# Design Review Board Meeting Tuesday, April 25, 2023 – 2:30 p.m. AGENDA

PROJECT NAME: 1036 William Hilton Parkway – Commercial Conversion	DRB#: DRB-000860-2023					
DATE: April 20, 2023	CATEGORY: Alteration/Addition					
RECOMMENDATION: Approval	Denial					
RECOMMENDED CONDITIONS:						
Provide updated plans for staff review and approval with the following:						
<ol> <li>Dumpster enclosure color to match building.</li> <li>Cement bollards to be painted a color that matches the building with white reflective tape applied.</li> </ol>						
MISC COMMENTS/QUESTIONS						
1. This project requires a Building Permit. Please contact Toney Pierce at tonyp@hiltonheadislandse permit.	e.gov or at 843-341-4675 with any questions about this					
2. This project requires a Development Plan Review.

PROJECT NAME: Captain Woody's	DRB#: DRB-000822-2023					
DATE: April 20, 2023	CATEGORY: Alteration/Addition					
RECOMMENDATION: Approval	Denial					
RECOMMENDED CONDITIONS:						
Provide updated plans for staff review and approval with the following:						
1. Lighting is to be 3500K or less.						
2. Provide a planting bed along the outside of the proposed stucco wall that is a minimum of 5 feet in

## RESPONSE TO ISSUES RAISED BY CORRIDOR DESIGN REVIEW

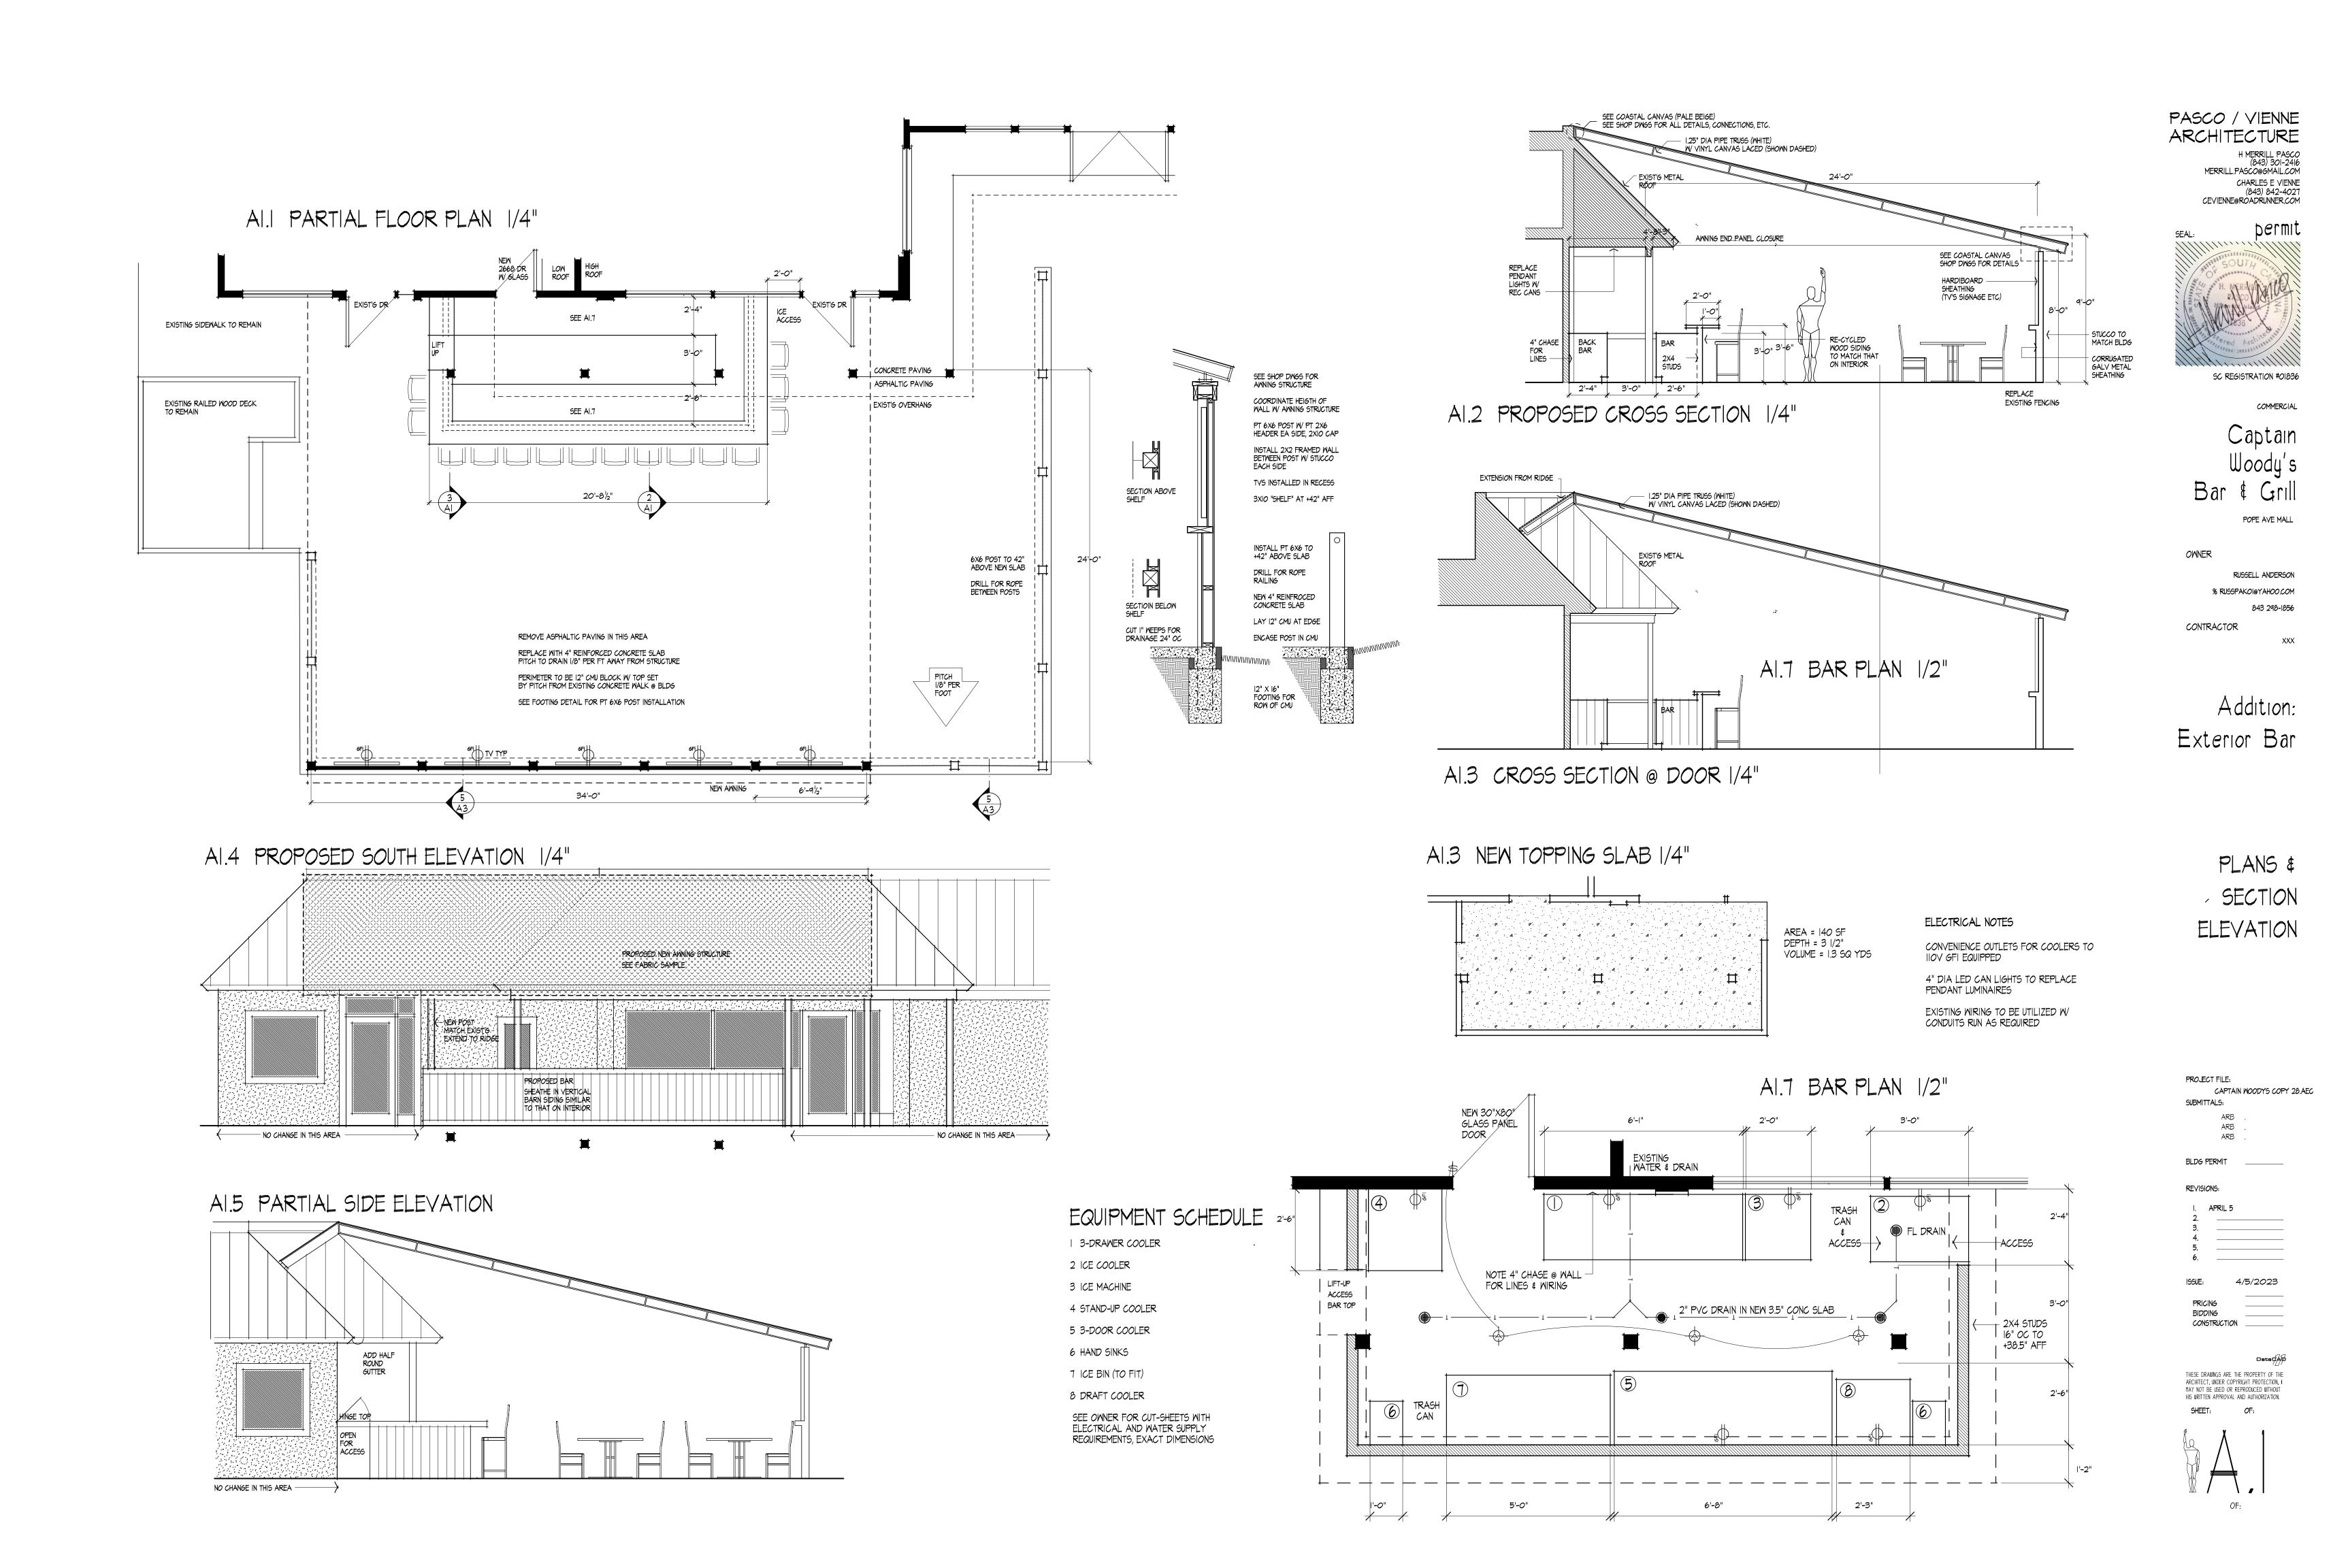
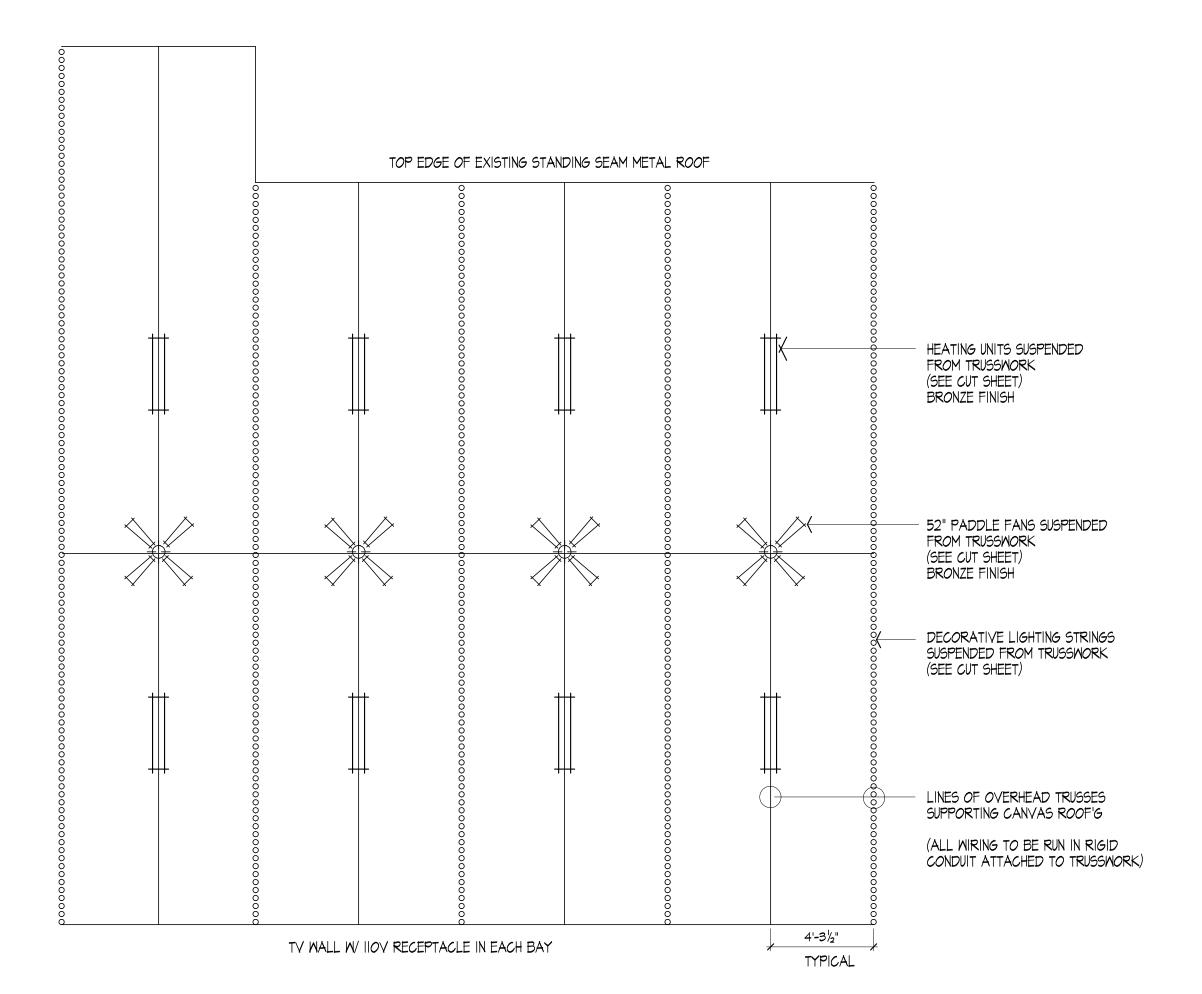
I.. PLEASE NOTE THAT COASTAL CANVAS SHOP DRAWINGS SUBMITTED SHOW ALL STRUCTURAL CONNECTIONS AND DETAILS OF JOINERY; 5 SHEETS. NOTE ALSO THAT THESE SHOP DRAWINGS CALL OUT ALL COLORS/FINISHES.

2. PLEASE NOTE THAT THE BELOW-BAR EXTERIOR CLADDING WILL BE DISTRESSED VERTICAL BOARD MATCHING THAT ON INTERIOR.

3. PLEASE NOTE THAT ALL EXPOSED FINISHES ON SUSPENDED DEVICES UNDER THE AWNING WILL HAVE BRONZE FINISH (MATCHING GUTTERS ON METAL ROOF)

4. NOTE THAT ARCHITECTURAL CONSIDERATIONS GOVERN EXTENSION OF CANVAS ROOF STRUCTURE TO TOP COPING OF EXISTING METAL ROOF, AS WELL AS ADEQUATE PITCH TO INSURE PROPER DRAINAGE..

5. NOTE THAT EXTERIOR "TV-WALL" AT THE PARKING LOT HAS BEEN RAISED TO MATCH HEIGTH OF EXISTING SOFFIT (APPROX 2'), AND THAT EXTERIOR OF WALL WILL BE IN MATCHING STUCCO.

6. NOTE THAT AWNING COLOR SUBMITTED IS A NEUTRAL PALE BEIGE COMPATABLE WITH THE PALETTE OF THE RESTAURANT STRUCTURE.
